DIRIGO ENGINEERING

May 6, 2024

Introduction

**Re: Sangerville Town Office
Foundation Assessment**

First Floor Wall Crack

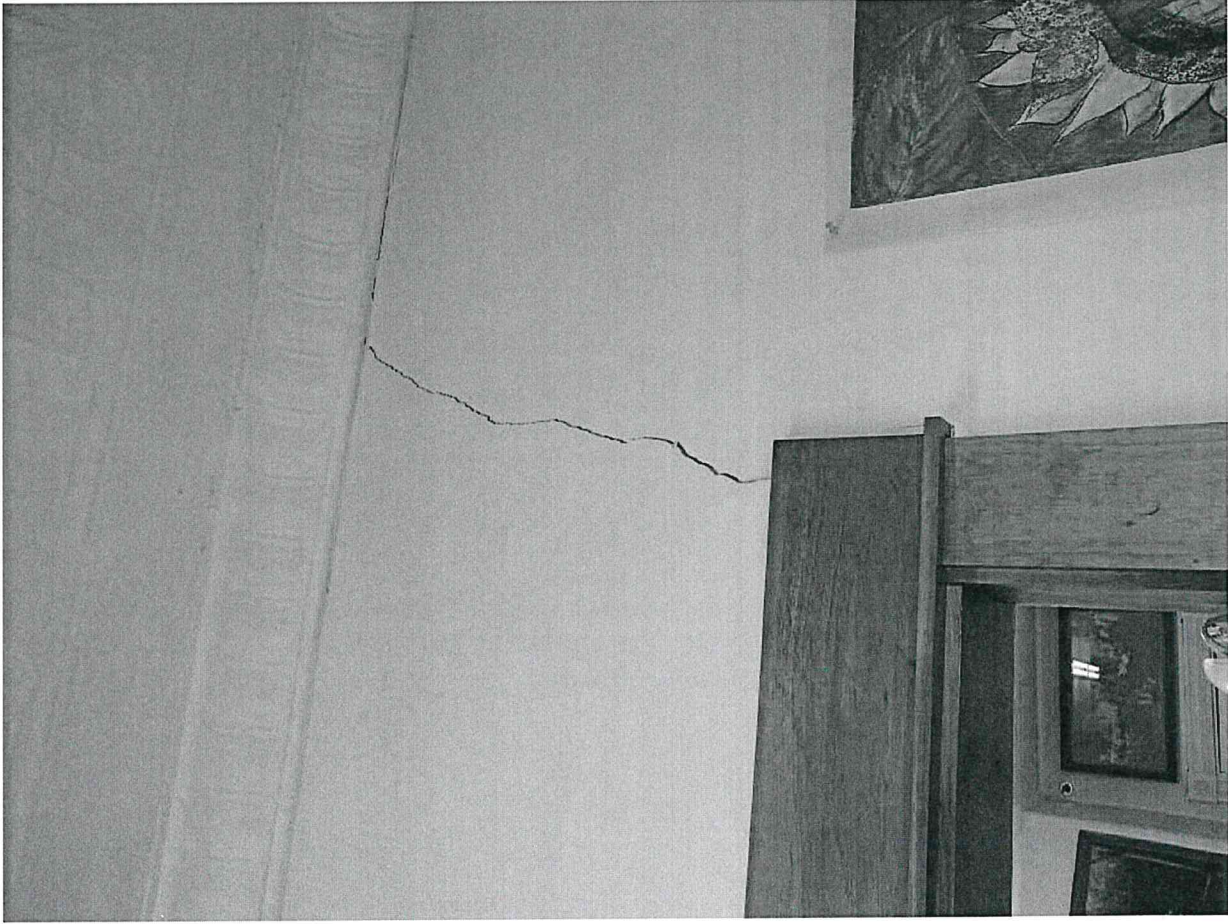
Due to insufficient drainage along the foundation, freeze/thaw cycling, and settlement of the original stone walls, the foundation walls have begun to buckle in several locations. The buckling is evident along each foundation wall. The brick foundation layer has several locations that are cracked, settled, and are bowing.

During the visit we also briefly looked at the structural framing located in the basement. The existing floor joists and beams supporting the joists have severe cracks along the members. The framing is a concern due to the age, condition, and lack of supports. The existing structural members have several structural defects. The existing floor joists have all been notched at the bottom of each floor joist. The floor joists bear the load onto ledgers and/or beams. The notching method creates stress concentrations in the middle of the floor joists. The stress concentration can cause the floor joists to split in the horizontal direction, which over time may cause the joists to fail.

In conclusion, the existing building needs structural attention and repairs. In order to reach the required structural capacities required by code, the beams, joists, and rafters would all need to be redesigned for sistering or replacement. The first floor framing would need additional columns installed, as well as additional steel beams to support the floor joists. The notched and bored joists and beams would require repair. The foundation walls should be redesigned and rebuilt. The exterior drainage surrounding the foundation walls should be addressed as well re-grading of the site to ensure proper drainage of ground and surface water. The other alternative to the invasive and costly repairs would be constructing an entirely new facility at the existing site or an alternative location.

Ceiling above balcony

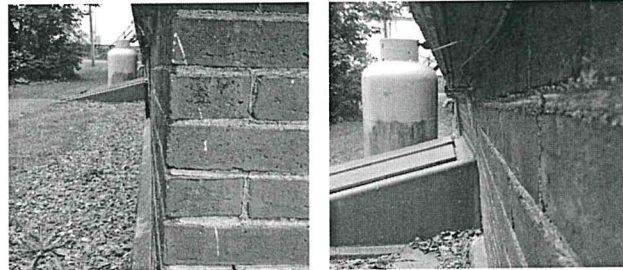
Notes: Tin ceiling above balconies appear to have rust/ corrosion which appears to be from water intrusion. Recommend roof is inspected for leaks and repaired, and tin ceiling is repaired/ replaced to prevent mold/ mildew and un fastened ceiling falling.

Basement wall bulkhead side

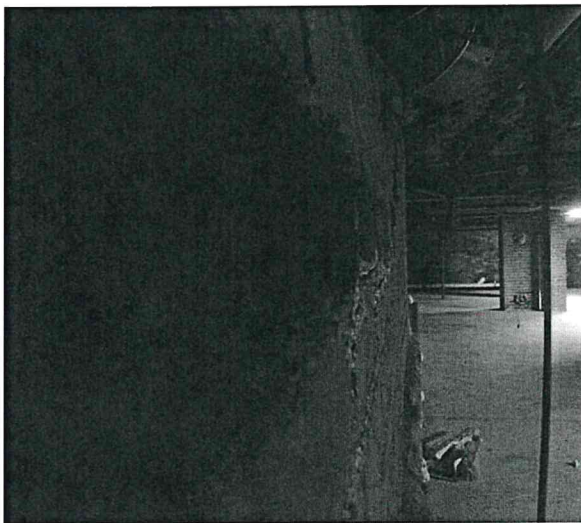
At bulkhead looking toward road, wall has evident movement. Recommend an engineer provide a structural assessment of the building and repaired.
